SERVICE BULLETIN # 00042

SUBJECT: Coke Reset with Sequencing for Forced Purchased (No Escrow)	
MODELS: Merlin 2000 (Coca-Cola)	
KIT NUMBER	KIT DESCRIPTION
010187	Coke Reset with Sequencing for Forced Purchased Kit

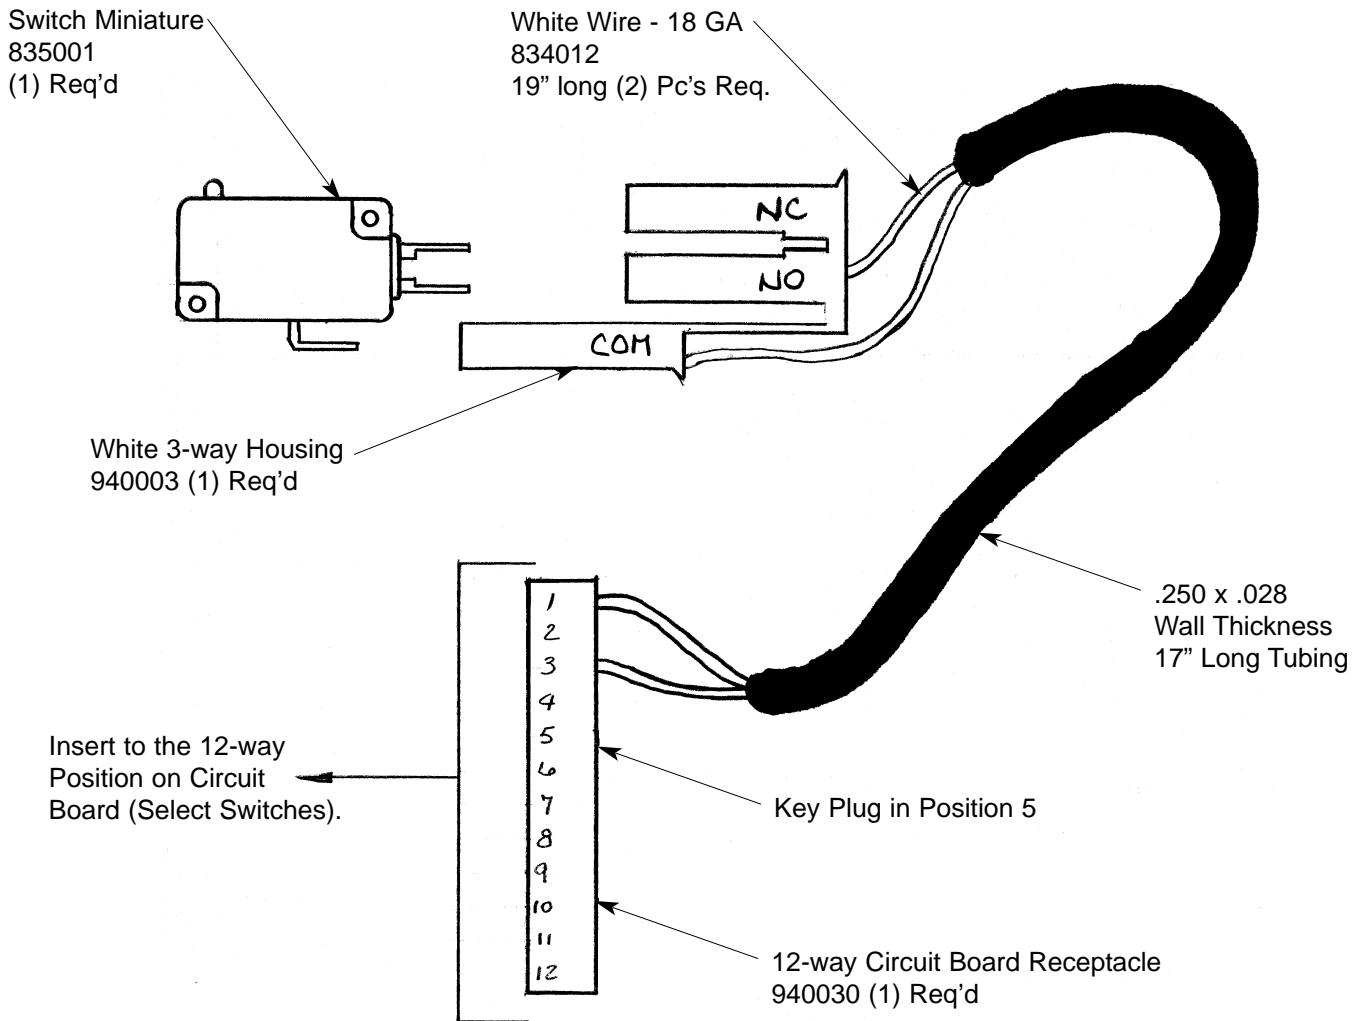
1. Find the 12-way white select panel plug on the control board and unplug it.
2. Plug the jumper wire switch assembly into this position.
3. Depress the mode switch, and then depress the .25 payout switch and the LED display should read **OPT** for the option mode.
4. Toggle the jumper wire switch and the display will read **ON** or **OFF**. **ON** is for forced purchase, and **OFF** is for full escrow.
5. Remove the jumper wire switch assembly and replace the select panel harness.
